ADDENDUM #01

INVITATION TO BID #01

RENOVATION TO THE BRANFORD POLICE HEADQUARTERS 33 LAUREL STREET BRANFORD, CT 06096

Supplement

**MECHANICAL
 JAIL CELL
 SMOKE
 CONTROL
 SYSTEM
 DIAGRAMS**

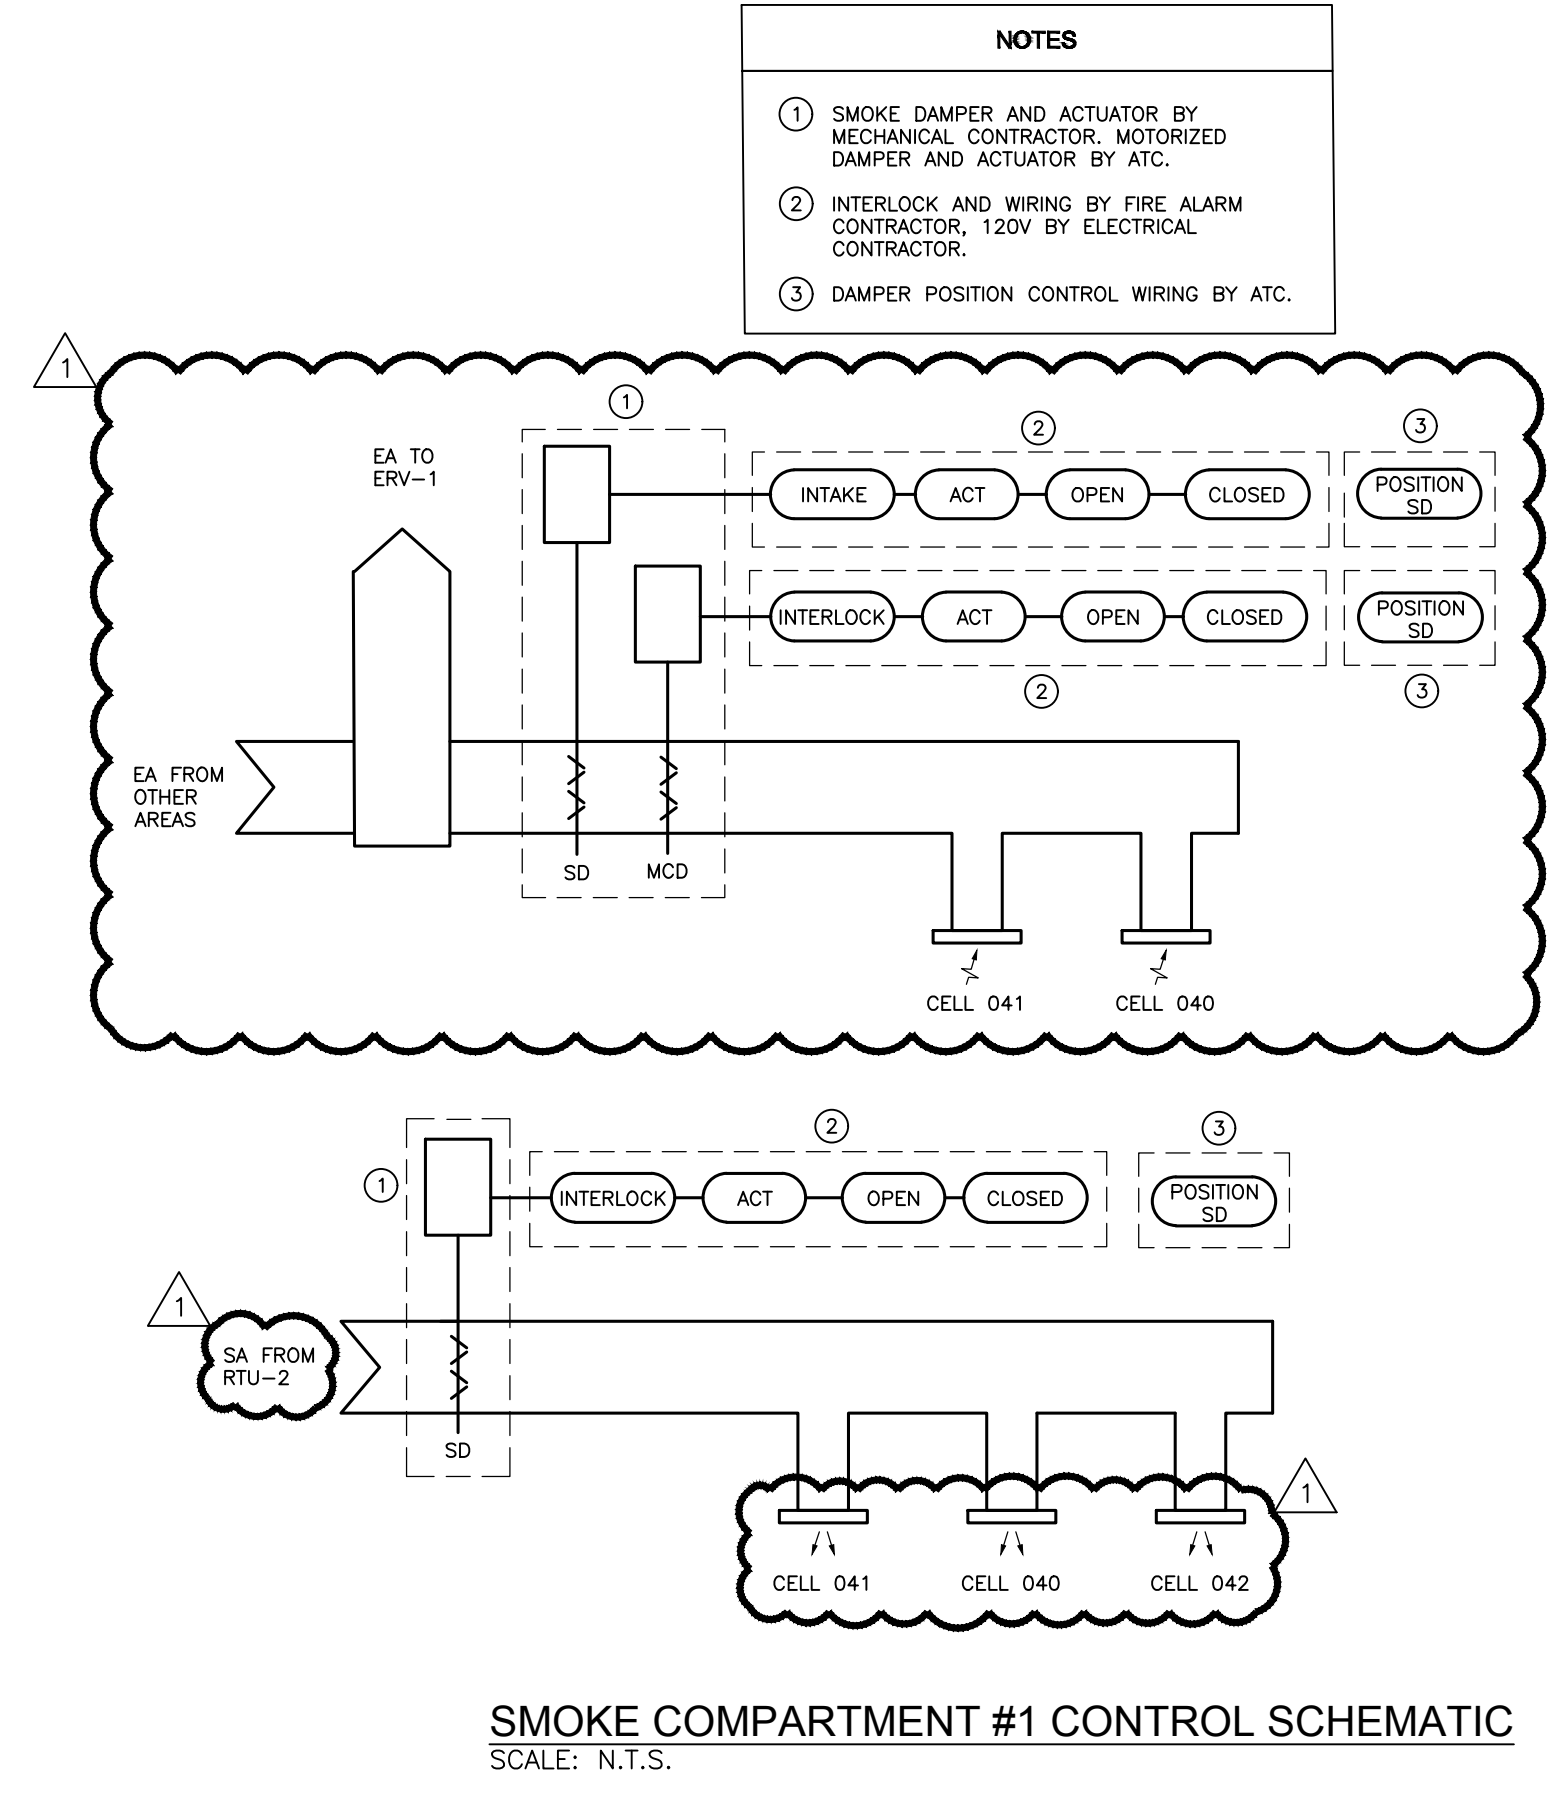
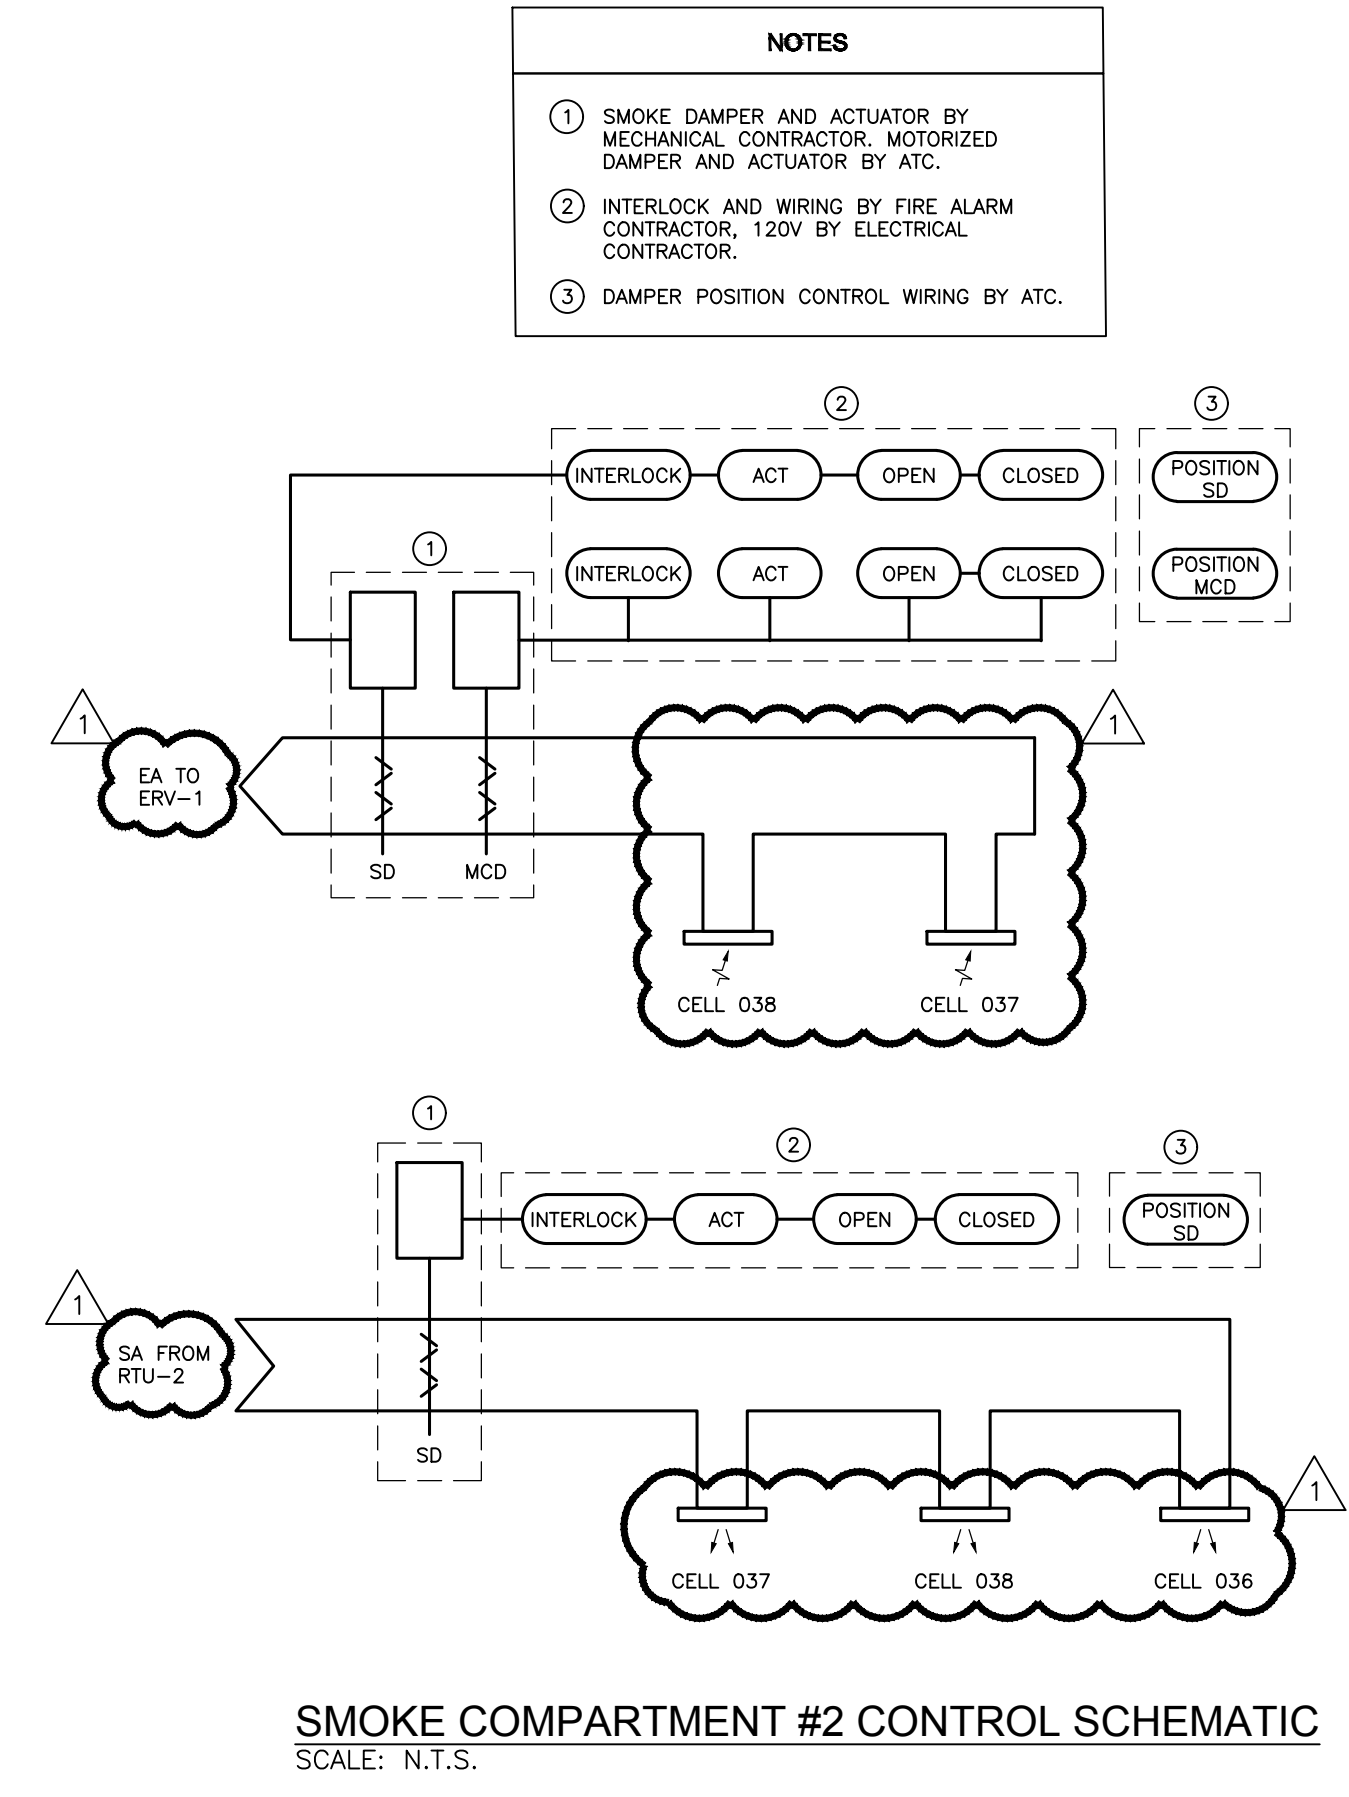
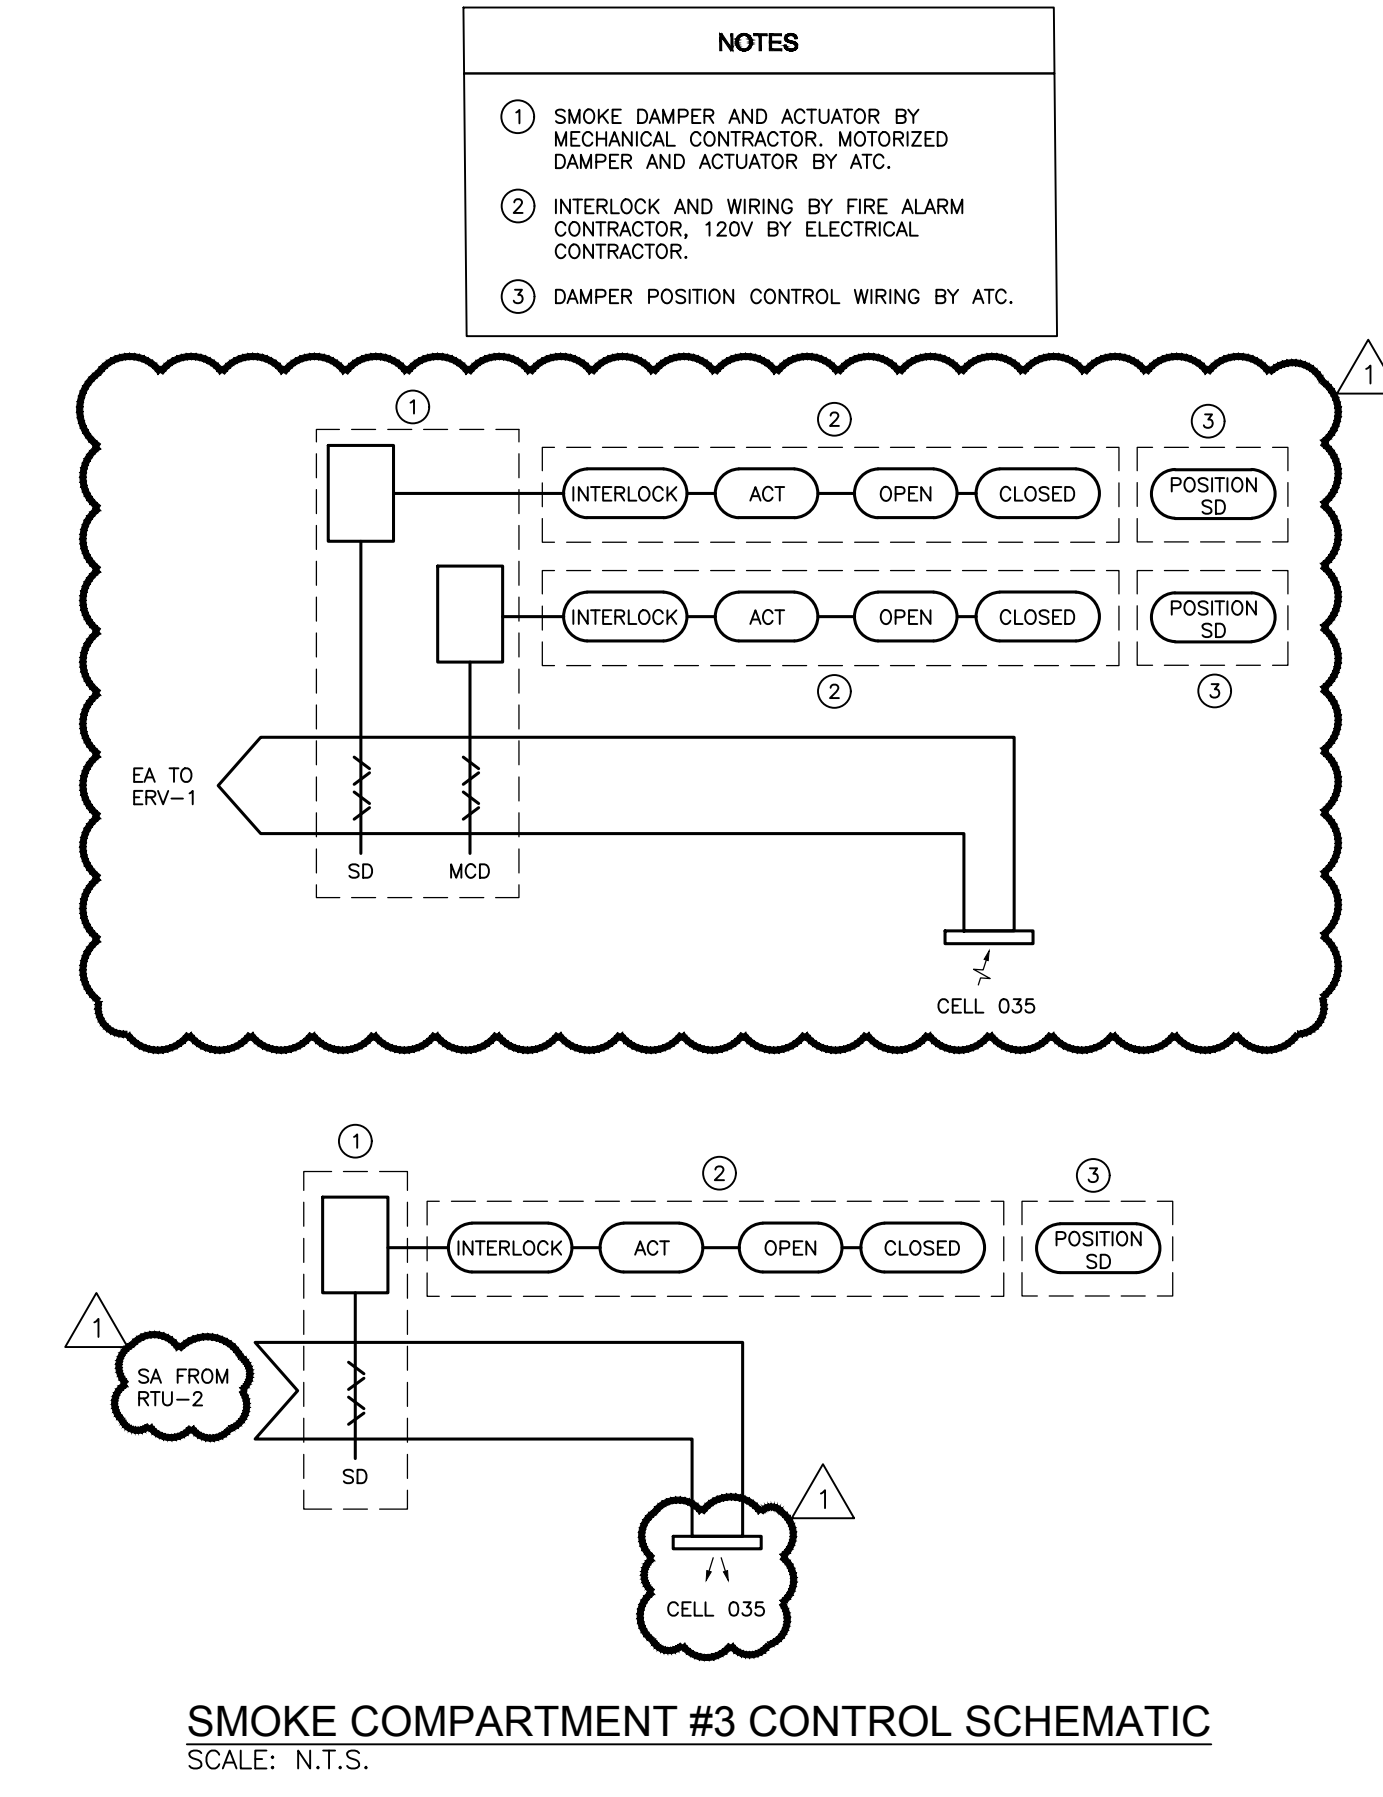
1. Drawing number "M-1.0", drawing title "Mechanical Plans", revision number "1", revision dated "09/03/24", and revision description "Pre Bid ASI".
2. Drawing number "M-2.5", drawing title "Mechanical Jail Cell Smoke Control System Diagrams", revision number "1", revision dated "09/03/24", and revision description "Pre Bid ASI".

M-2.5 - Mechanical Jail Cell Smoke Control System Diagrams, revision number "1", revision dated "09/03/24", and revision description "Pre Bid ASI".
